3 June 2026

Section 4.55(1A) Modification Application – SSD-74670005 UNSW G25 Education Building, UNSW Kensington Campus

The proposed modifications to the approved development are detailed in **Table 1** below. Excerpts of the approved and amended architectural plans are provided at **Figure 1** to **Figure 23**.

Figure 2 Proposed lower ground plan

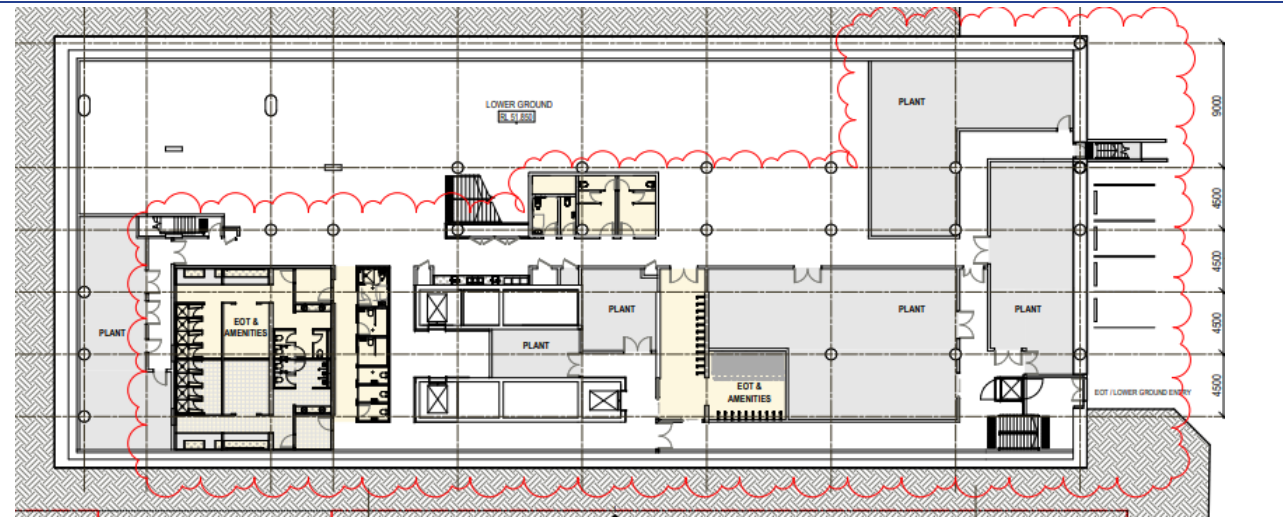
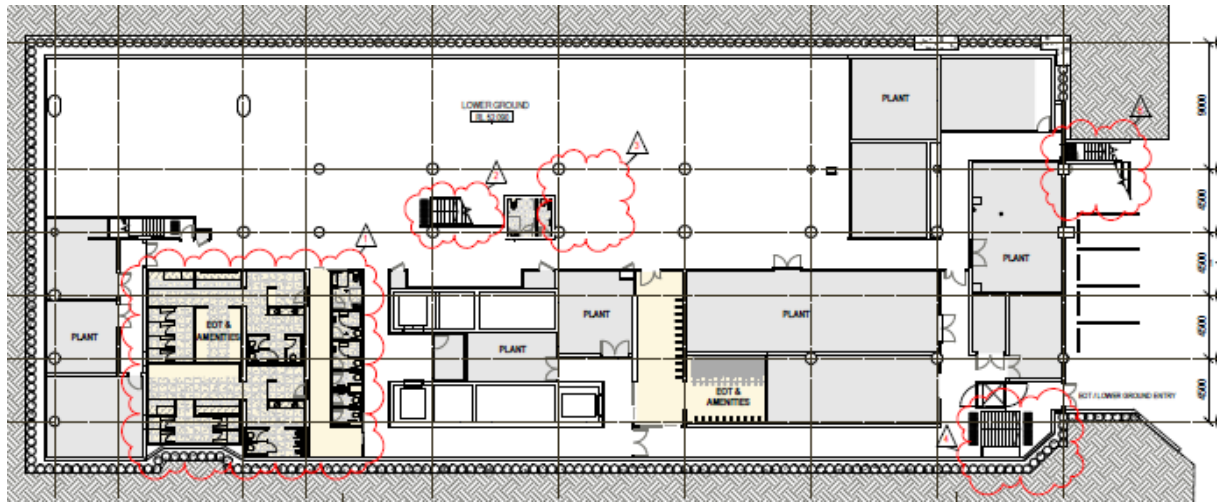
Location	Proposed Modifications
	Marginal increase in Gross Floor Area (GFA) from 19,567m ² to 19,630m ² arising from general design development across each level, including:
Gross Floor Area	• Removal of internal voids. • Stair width refinements. • Plant room changes.
	General architectural design development including:
Lower Ground	• Amendments to end-of-trip. • Access and amenity arrangements. • Reduced stair width to lower ground level. • Minor amendments to amenities configuration. • Stair location changes. • Alignment of Fire Stair 1 wall with the lift core in response to piling wall / structural coordination. A comparison between the approved plan and proposed modification is illustrated within Figures 1 and 2 below.

- Reduced stair width to lower ground level.
- Minor amendments to amenities configuration.
- Alignment of Fire Stair 1 wall with the lift core.
- Minor reconfiguration to base building services and core components on all levels (e.g. cupboard sizing).
- Entry refinements.
- Additional door to substation.
- WC and partition amendments.
- Note added for secondary fire booster in alignment with FEBQ.

Figure 4 Proposed ground plan

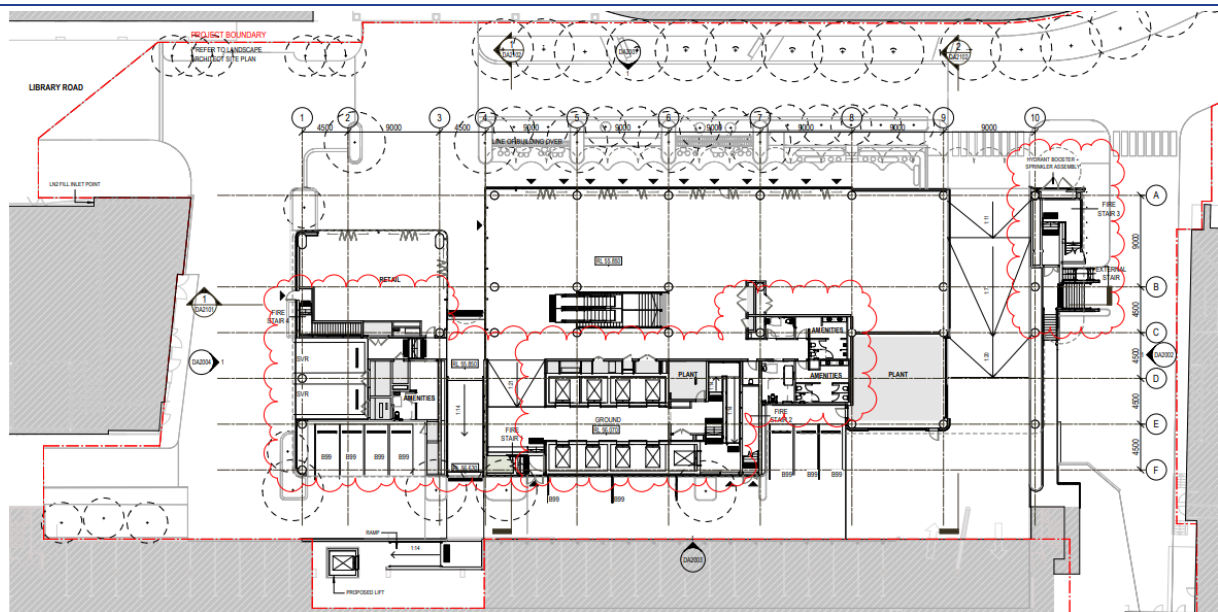
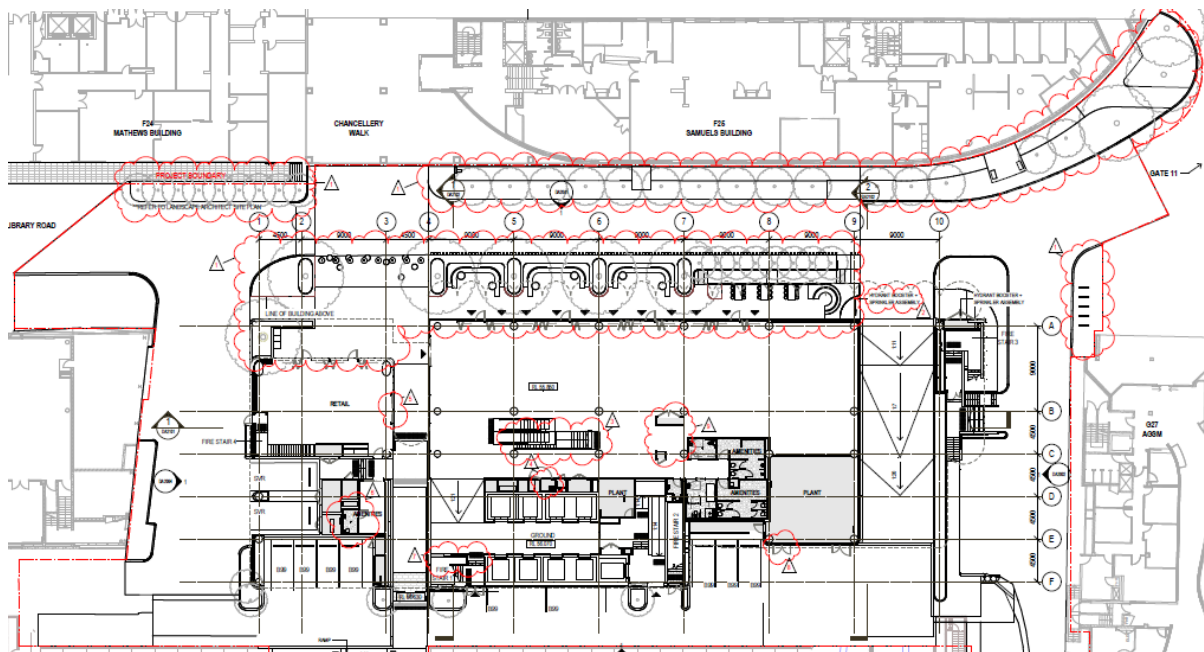
- Ground plane and public domain works
- Paving and surface finishes
- Tree and understorey planting
- Swale planting
- Retaining walls and edges, furniture, lighting, pedestrian crossing interfaces and Library Walk / shared zone upgrades.

Figure 6 Proposed level 1 plan

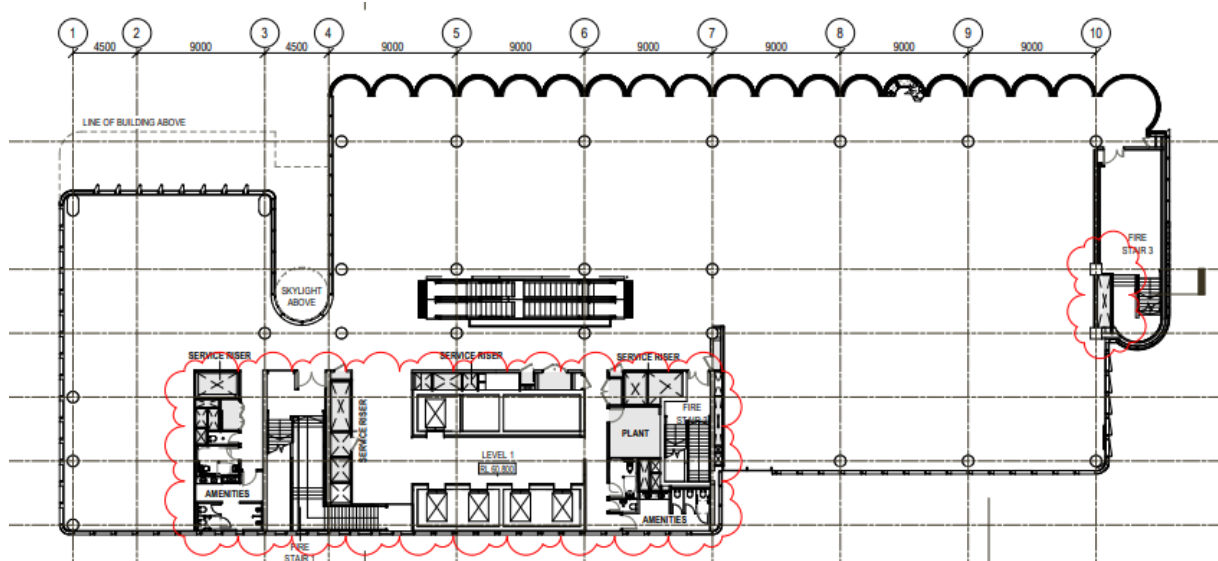
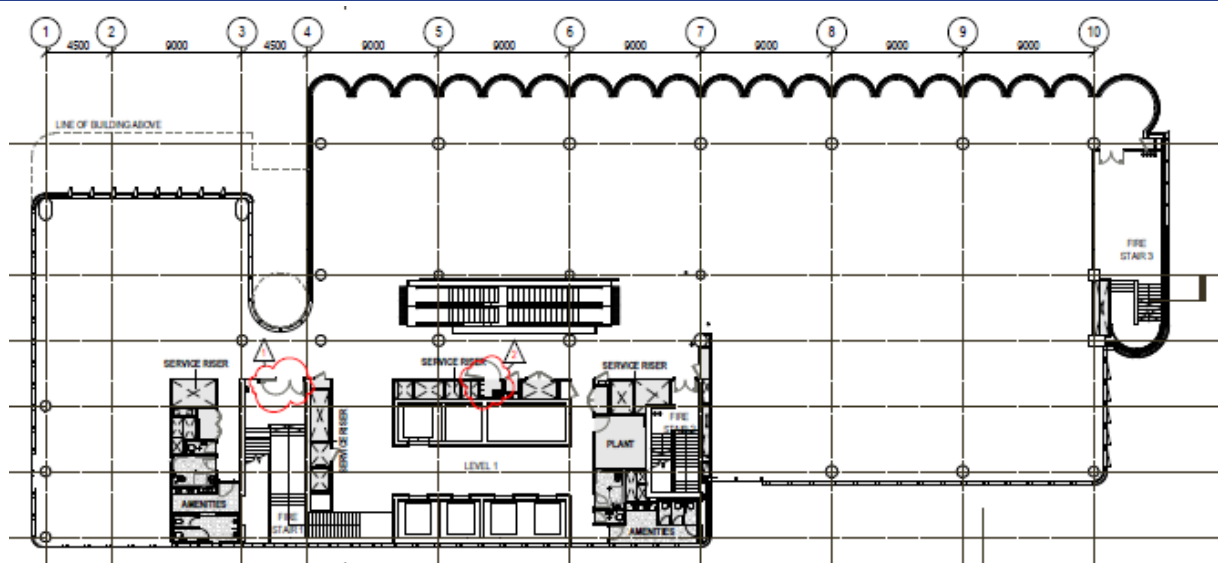
- Minor reconfiguration to base building services and core components on all levels (e.g. cupboard sizing).

Figure 8 Proposed level 2 plan

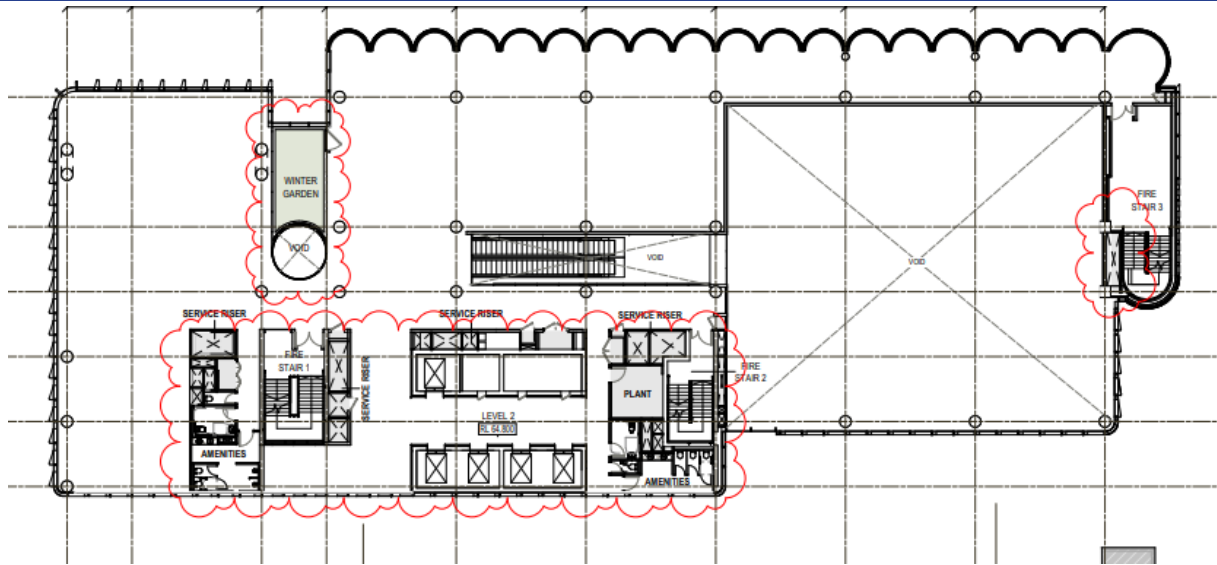
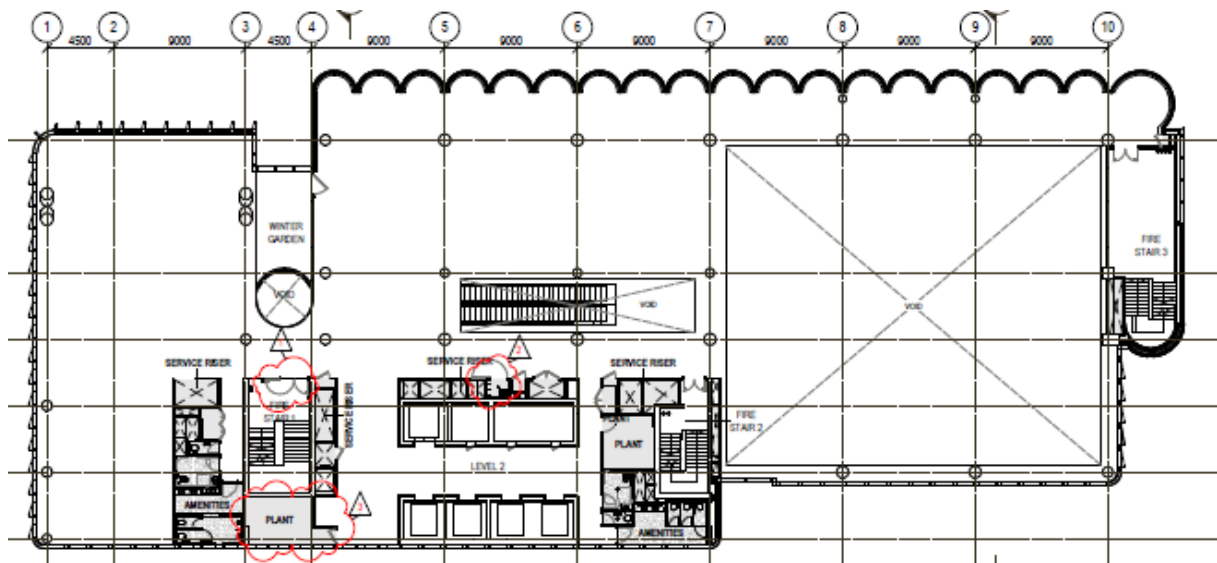
- Minor reconfiguration to base building services and core components on all levels (e.g. cupboard sizing, door configuration and plant room).

- The landscape drawings and architectural plans have been amended to only provide winter garden areas on Levels 2,4 and 6.

Figure 10 Proposed level 7 plan

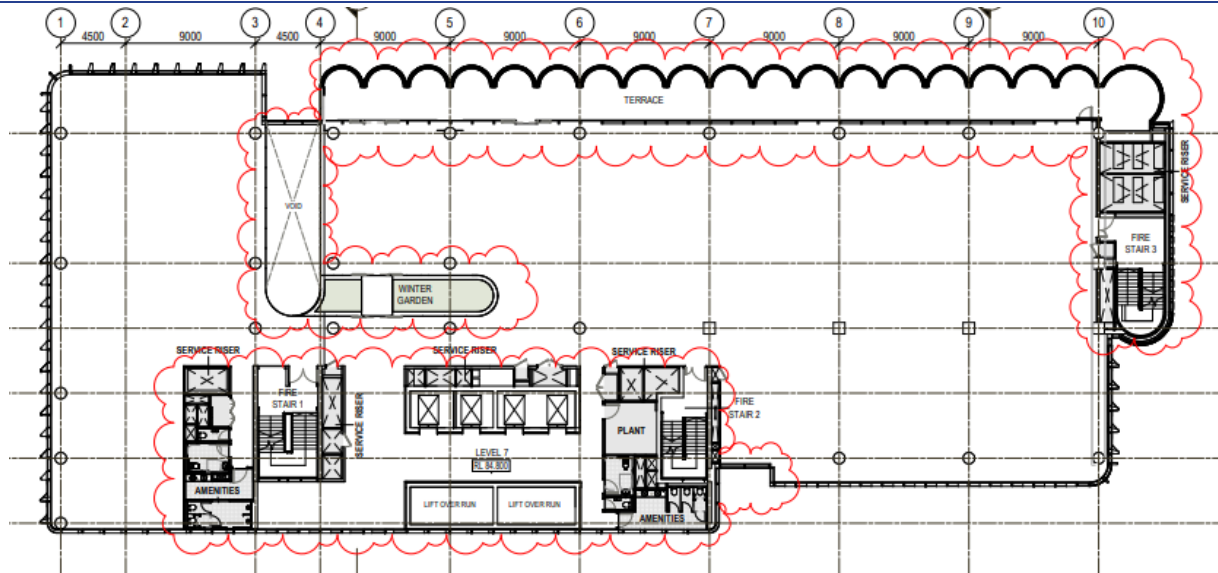
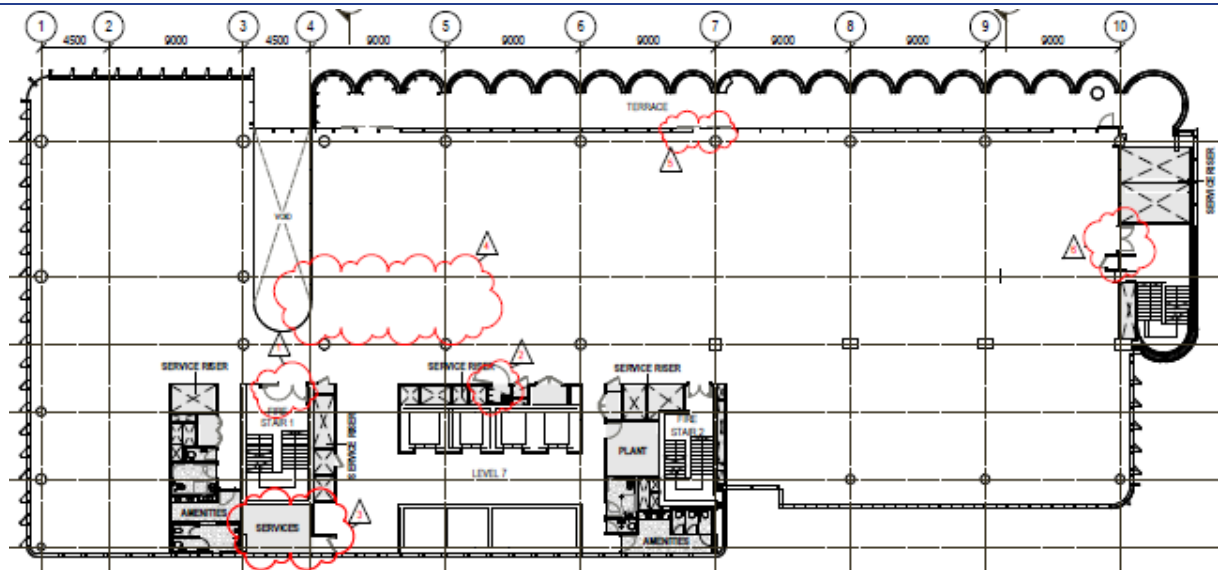
- Door configuration amendments.
- Additional AV plant room.
- Removal of internal void.
- Relocation of door to external terrace.
- Minor reconfiguration to base building services and core components on all levels (e.g. cupboard sizing).
- Removal of winter gardens at relevant levels and removal of associated skylight elements.

- Additional safety tensile mesh FAC06 to the Level 7 external terrace in response to Safety in Design considerations.

Figure 12 Proposed level 8 plan

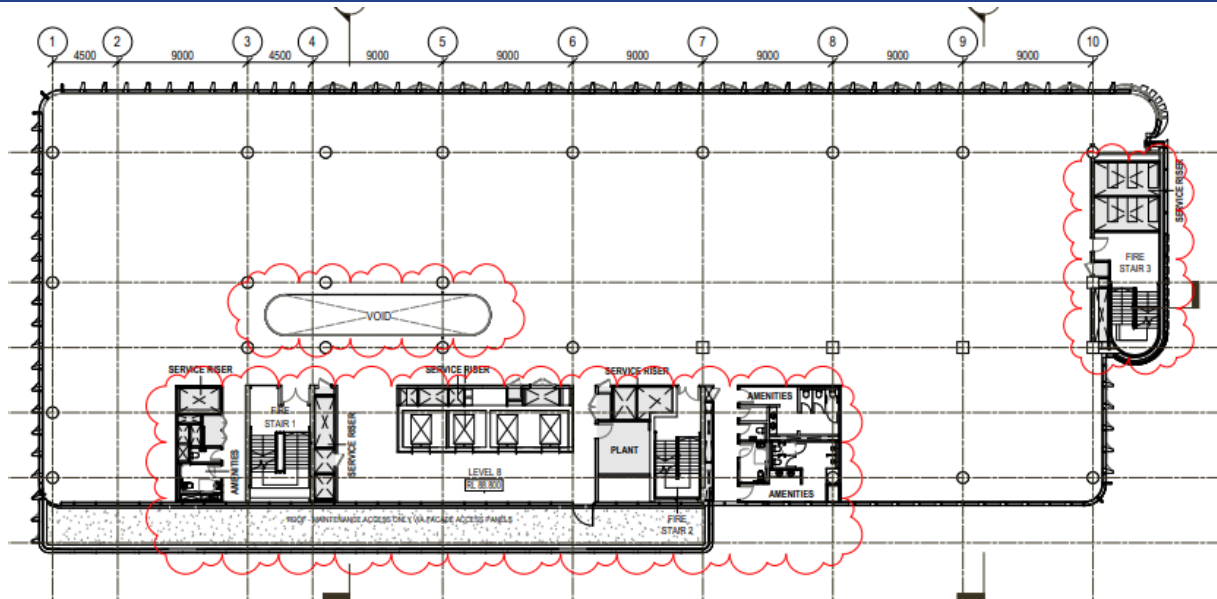
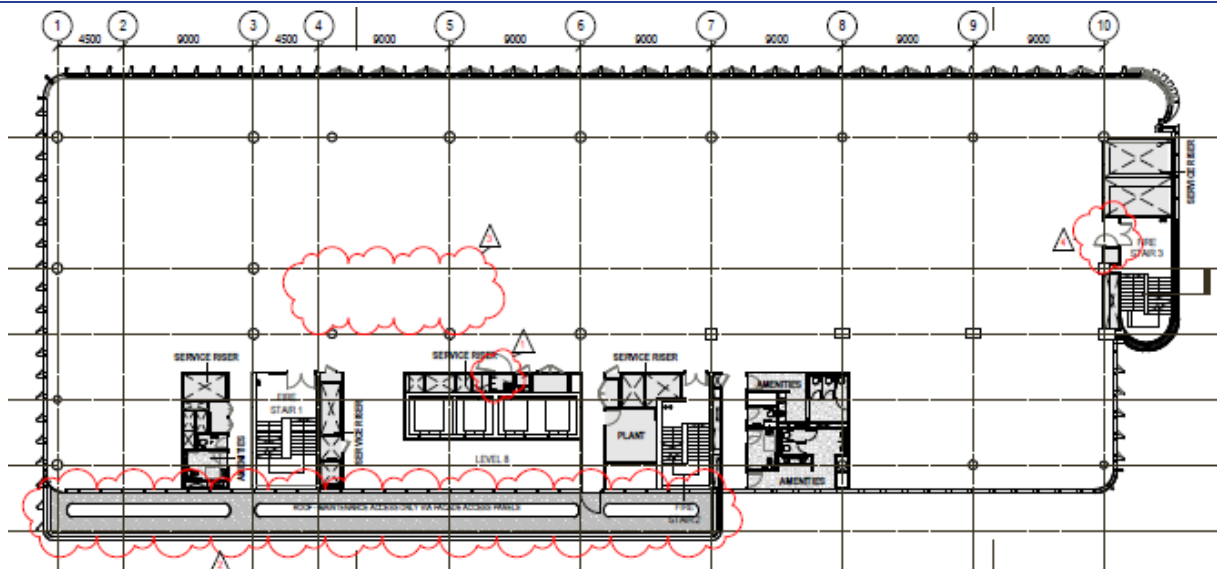
- Removal of internal void.
- Minor reconfiguration to base building services and core components on all levels (e.g. cupboard sizing).
- Green roof planting to the southern terrace.
- Removal of winter gardens at relevant levels and removal of associated skylight elements.

- External rooftop garden works and planting.
- Rooftop surface finishes.
- Planting layout updates to suit design changes and maintenance access requirements.

Figure 14 Proposed level 9 plan

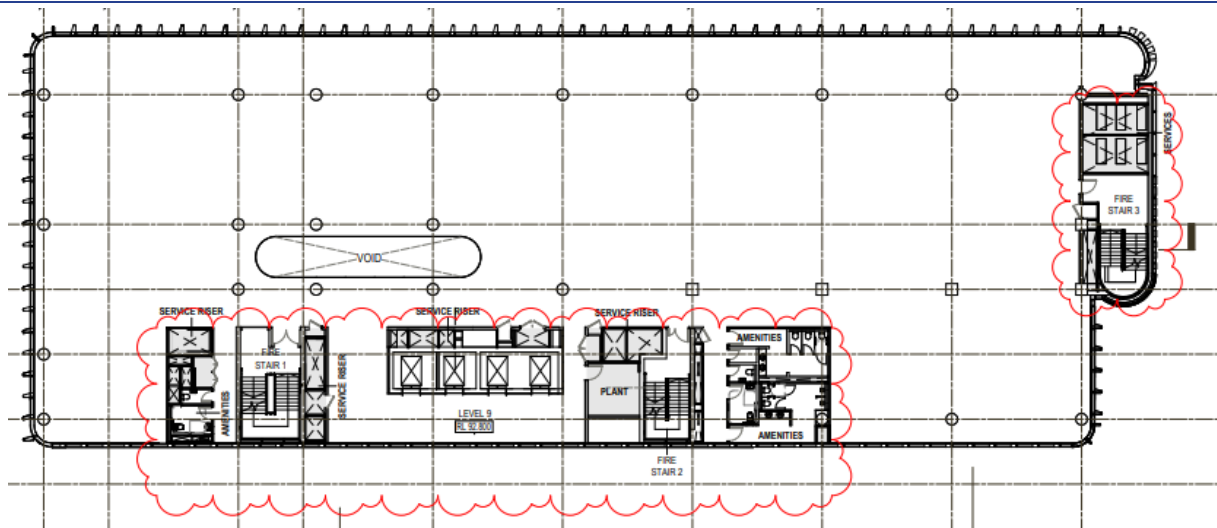
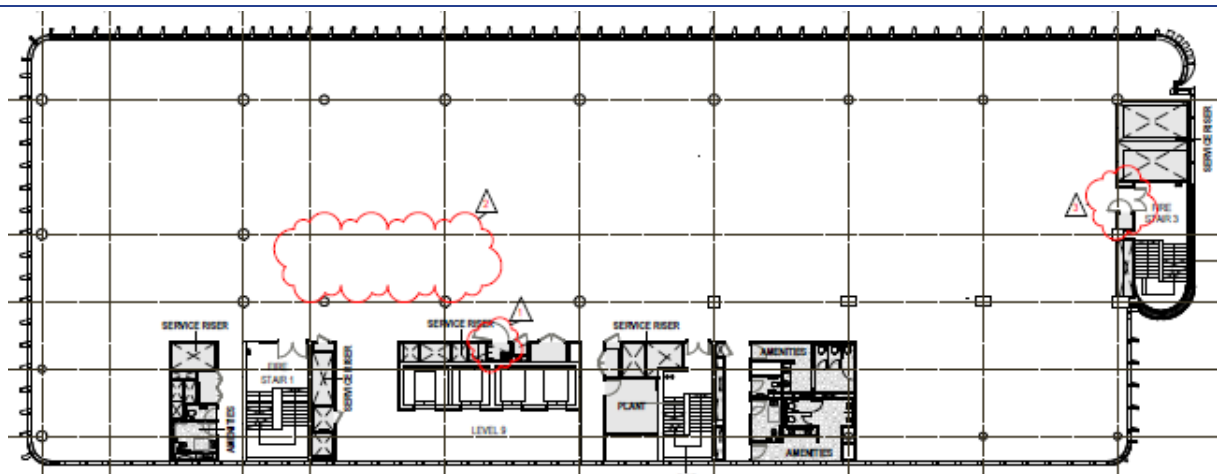
- Door configuration amendments.

- Removal of internal void.
- Minor reconfiguration to base building services and core components on all levels (e.g. cupboard sizing).
- Removal of winter gardens at relevant levels and removal of associated skylight elements.
